City of Maple Ridge

PUBLIC HEARING

PUBLIC HEARING AGENDA

**1a) 2017-473-RZ
13616 and 13660 232 Street**

Figure 1 – Silver Valley Blaney Hamlet Current Land Use Designations

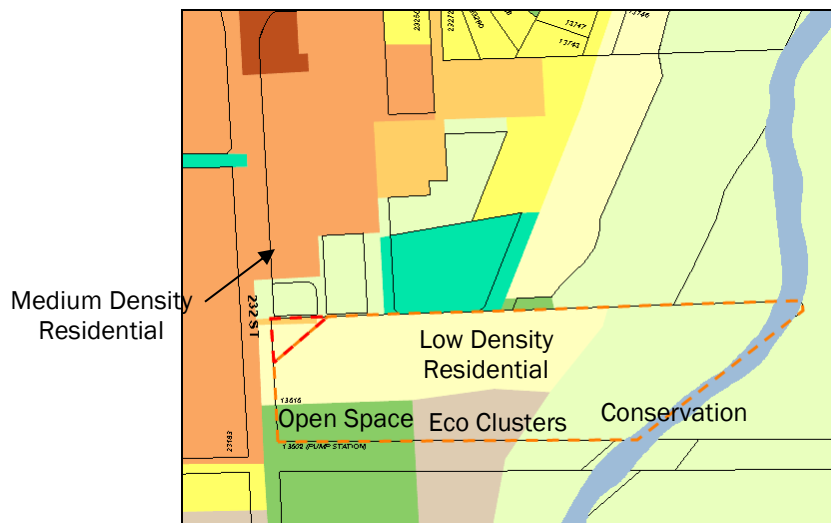
The subject properties are located within the Blaney Hamlet of the Silver Valley Area Plan and are currently designated *Low Density Urban, Medium Density Residential, Eco Clusters, Open Space and Conservation* (see Figure 1). For the proposed development, an OCP amendment will be required to adjust the boundaries to *Low Density Urban, Medium Density Residential, Medium/High Density Residential, Open Space and Conservation* designations to respect the current pattern of development in the area and better locate the *Open Space* area (see Figure 2 and Appendix C).

Designated *Open Spaces* are intended to be linked by a network of greenways throughout the area plan; however the locations of these *Open Space* designated areas were not ground-truthed when the Silver Valley Area Plan was developed. In this location, it appears as though there was a linkage

proposed to the North Alouette River through the un-opened 136 Avenue Right-of-Way, with additional *Open Space* to be provided on the private properties north and south of the Right-of-Way.

Figure 2 – Proposed Land Use Designations

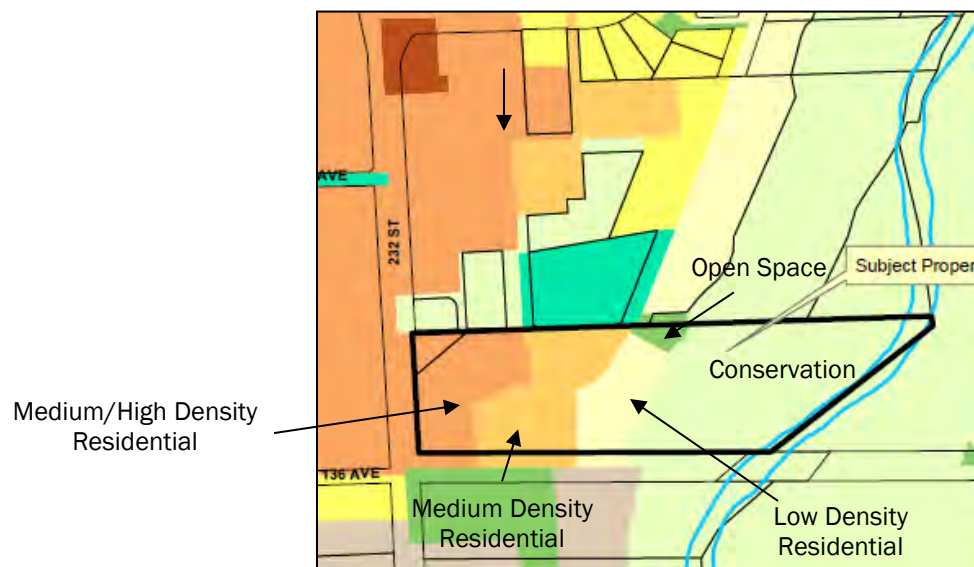
The proposed OCP amendments are supportable as they create a larger *Open Space* area adjacent to the *Conservation* area, and also maintain the intent of the Silver Valley Area Plan policies, as a linkage remains along the un-opened road Right-of-Way.

10 Unit Street Townhouse
13616, 13660 232 St, Maple Ridge

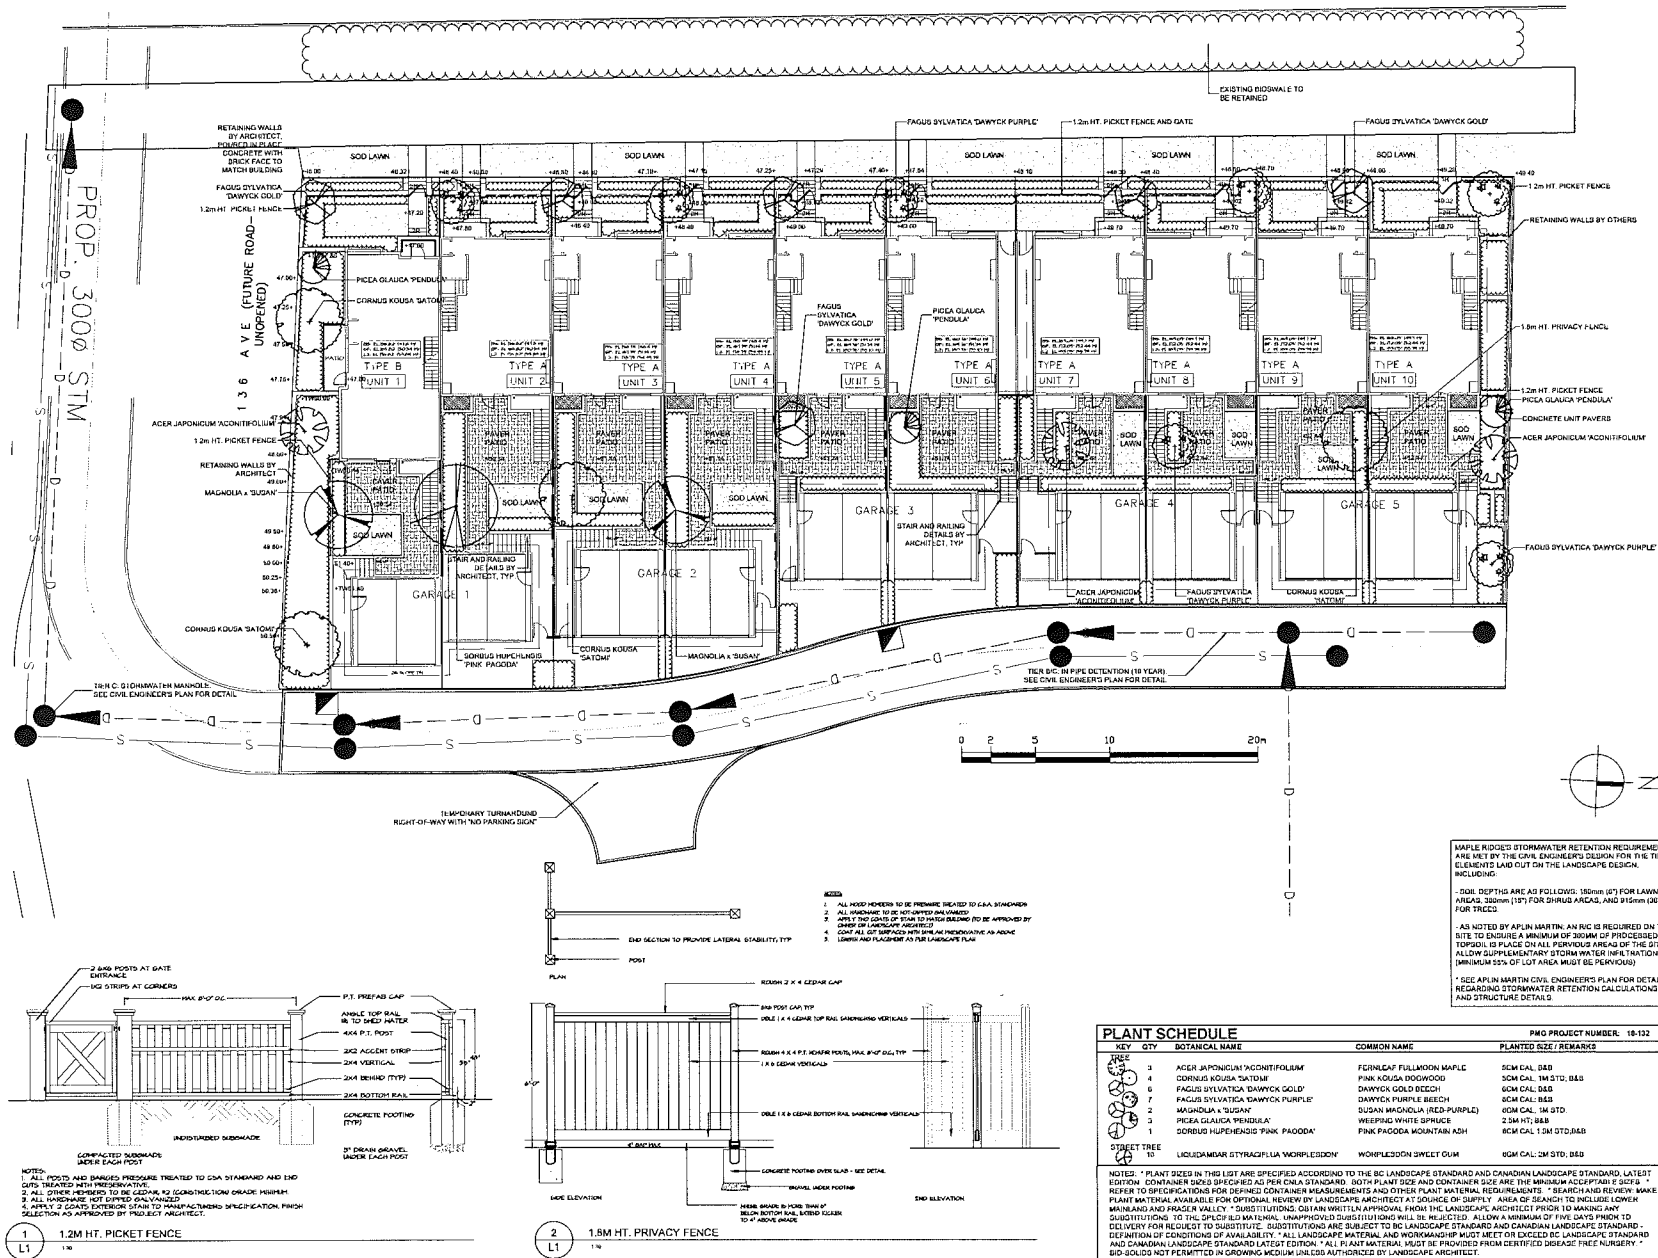
1. Coordinate grades between architectural and landscape plans south elevation, Unit 1;

3. Show retaining walls and fences in elevations to demonstrate height consistently in landscape and architectural drawings;

4. Provide a section through the north/south property line to show transition to future roadway;

6. Show context of pump station in plan view and elevation; and

7. Provide adequate landscape screening between Unit 1 and the pump station.

Grading has been shown from the architect's plan on the landscape plans.

Shown on the architectural plans.

Shown on the architectural plans.

Shown on the architectural plans.
